# DHDC 23-8401

## APPROVAL DOCUMENT – POST AT WORK LOCATION

### CERTIFICATE OF APPROPRIATENESS

**RE: Application 23-8401; 2984 Iroquois, Indian Village Historic District**  
**Project Scope: Install driveway gate**

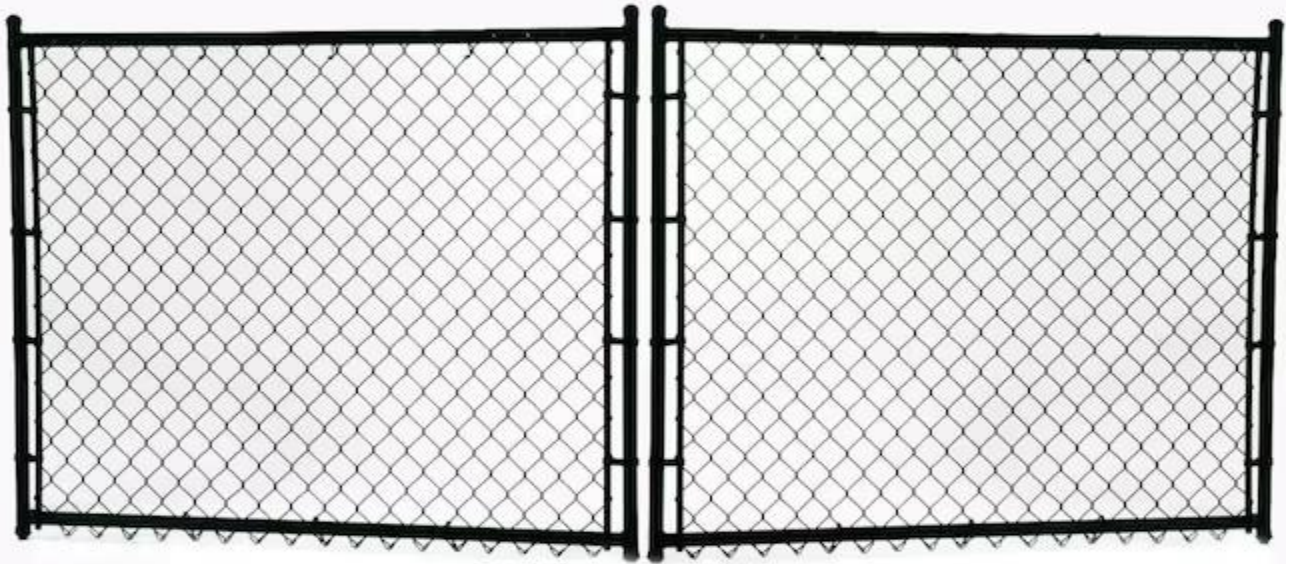
***With the condition that:***

- ***The proposed chain-link gate be installed for not more than two years’ time.***
